Issue 30: Question and Multiple Question Item

Figure 33. Question Group Class Diagram

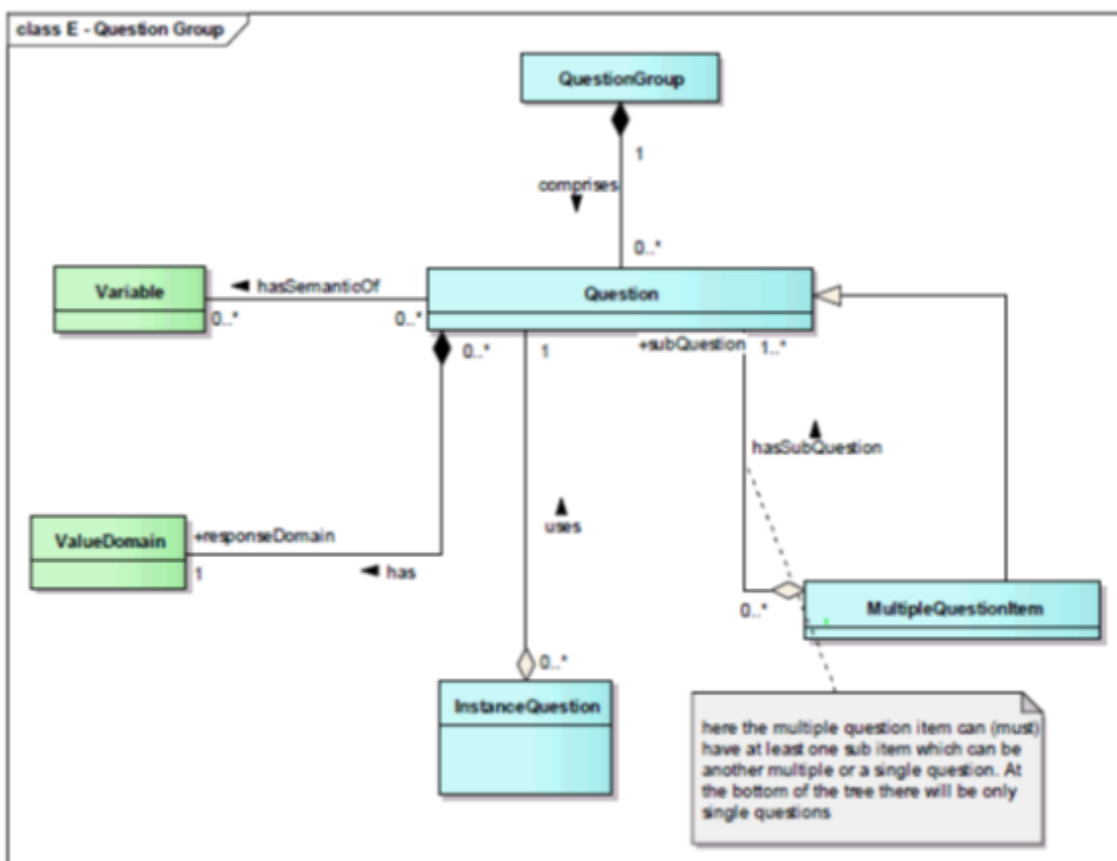
Currently the definition of question is ambiguous. The role in which it is being used in the current model is to conceptually describe a question (in an instrument), and yet it also has a subtype 'Multiple Question Item', which further defines a particular type of question, different to 'question'.

Should 'question itself be the definition of questions 'conceptually' (ie, it covers all types of questions), and then at an implementation level, the varying types can be further defined? Or are Question and Multiple Question Item significantly different enough that they warrant being two separate objects, in which case should it really be a subtype of Question?

The rule documented in Figure 33 implies it should be possible to identify what is a "single question". This might be termed a (single) "*Question Item*" which would be a more constrained 'subtype' of *Question* as an abstract.

If a *DDI3.2 Question Grid* would be considered a *Multiple Question Item* under GSIM then Figure 33 would seem to require 'sub-items' to describe (presumably) the individual 'single question' cells in the grid.

1. Remove Multiple Question Item as an object, and leave Question as a broader definition.

The definition of *Question* is broad enough that it can cover all types of question, regardless of whether it is a 'single' question or a multiple question item. To keep the model at a conceptual level, should there only be one object in this space (*Question*), and any further sub-types of this are decided in implementation?

2. Question as abstract object, with sub-types Question Item and Multiple Question Item.

Treat the *Question* object as an abstract object; and create another sub-type of *Question* to represent a 'single' question, called *Question Item*. That is, *Question Item* and *Multiple Question Item* would now both be sub-types of the abstract object *Question*. This would also involve changing the definition of *Multiple Question Item* (see picture and alternate definitions below). This option could also be expanded in the future for further types of question, for example if *Question Grid* was to be included as another question type.

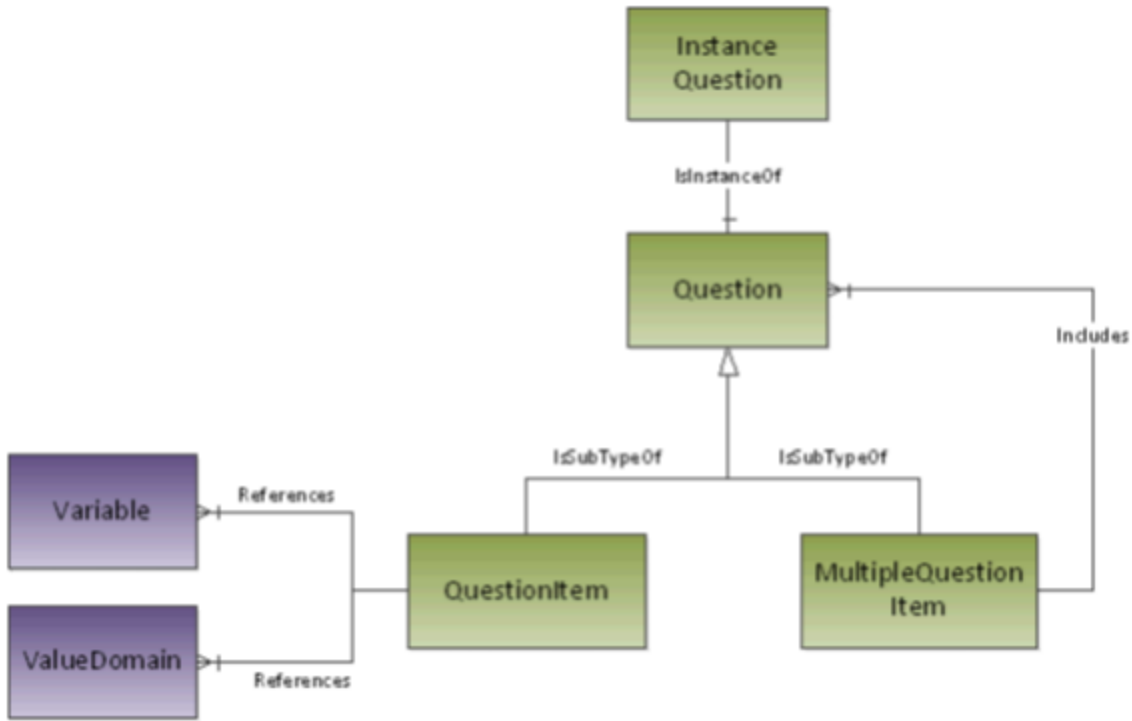
This comes back to the logical definition of *Multiple Question Item*. Would a *DDI3.2 Question Grid* correspond to a *Multiple Question Item* in GSIM terms or would it be considered a '*Question Item*' with a dimensional response domain?
